Item 7.2 Picardy Place Island, Public Realm Improvement Project

Spokes, the Lothian Cycle Campaign, welcomes the opportunity to comment on the above proposal and urges the committee members to commit to an investigation into how the needs of people who need to cycle to the north of the Picardy Place Island can be met. We have comments on other issues here, included at the end.

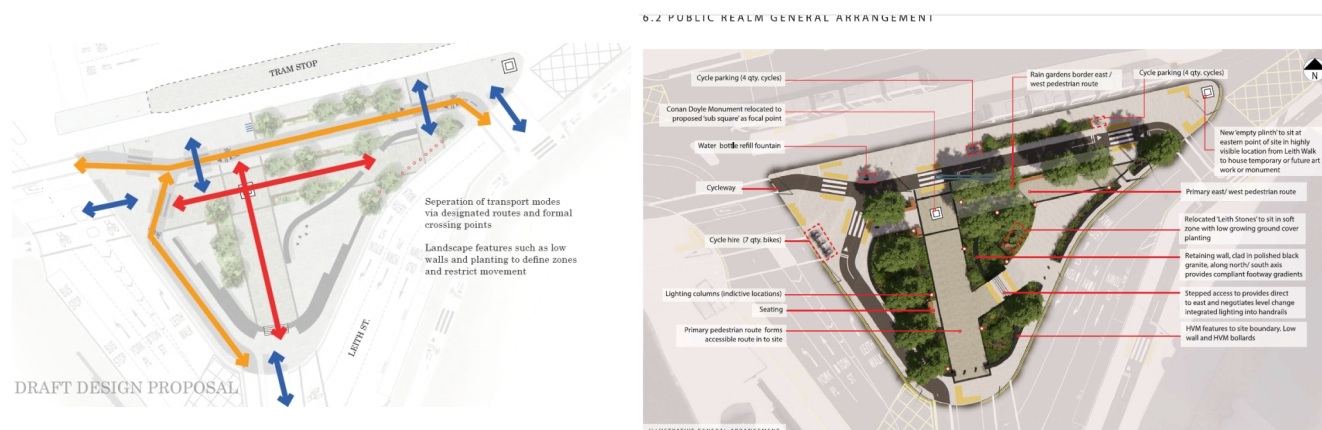
The Draft Design Proposal below shows cycle routes in orange, main pedestrian movement in red, and pedestrian crossings in blue. This has been incorporated into the Public Realm General Arrangement (below right). There is no safe cycling access to the businesses on Union Place (off the top of the illustrations) or to Union Street and Gayfield Square (above and to the right of the illustration). Indeed, there is no northbound cycle crossing from York Place until Annandale Street, some 450m away.

{Drawing rotated 180degrees to be of similar orientation to the other illustrations.}

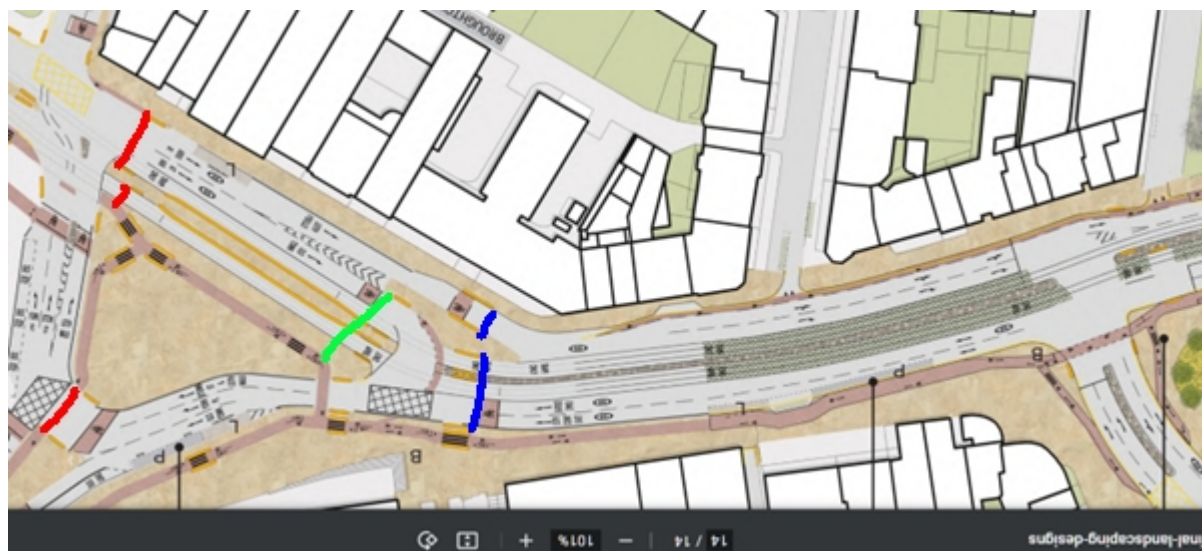
The Final Landscape Design below gives a clearer picture of the overall position, although it does not show clearly the cycle crossing to the SW island (outside John Lewis) or the one-way Toucan crossing to the island from the North that links to the cycleway from Broughton Street. For completeness I have added these (in red).

Cycle crossings must be provided from the main island to the NE island (as shown in Green) and from The Playhouse to the NE island (in Blue) to access the premises and streets at the North and North East of the drawing.

Under the present plans, cyclists coming from CCWEL (York Place), Leith Street and Leith Walk/London Road have absolutely no realistic route, let alone a safe route, to reaching those destinations!
